September 13, 2006

City of Westminster
Department of
Public Works
and Utilities

RE: Rocky Flats Environmental Technology Site Proposed Plan,
Dated July 2006

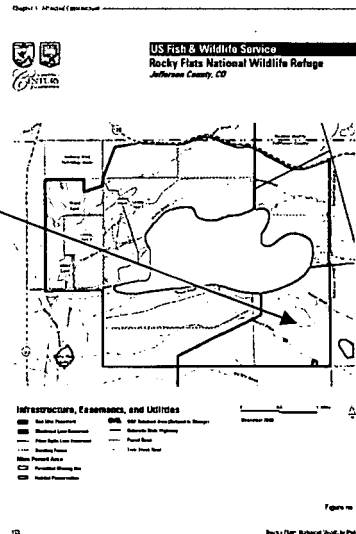
- 3.2.8 Revise the map, Figure 3, to move the boundary north of the Present landfill at least 300 feet from landfill boundary. It may be practical to follow the road north of the landfill, but the area northeast of the landfill should be pushed further north to protect the cap based on the proximity to the road and the cap.

Attachment 1

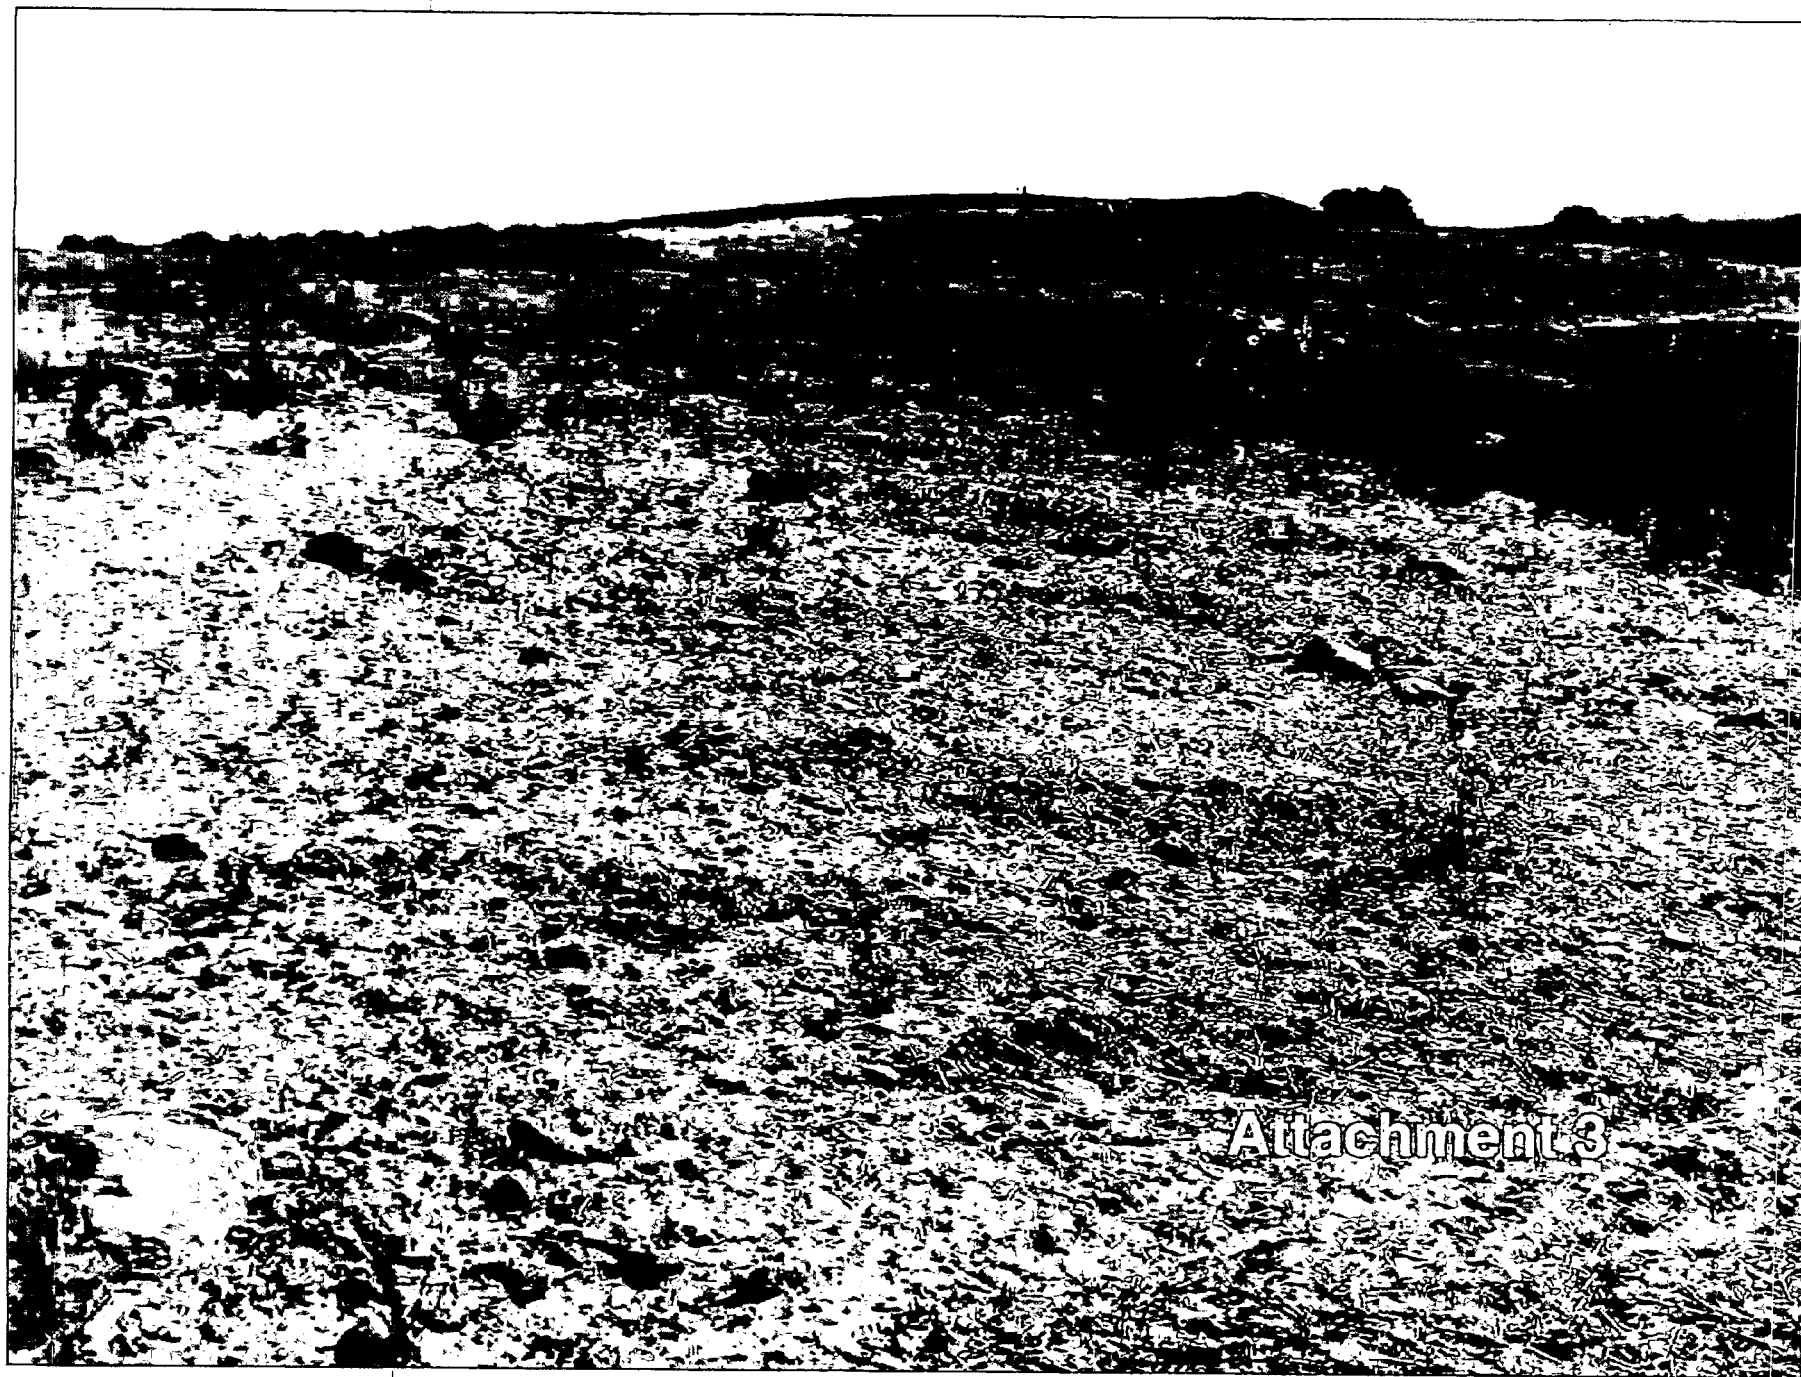
in C-2 and could potentially leave the site without being monitored. Clarify the basis for figure 3 in the Proposed Plan (Attachment 1) versus the proposed boundary in the Comprehensive Conservation Plan as identified below.
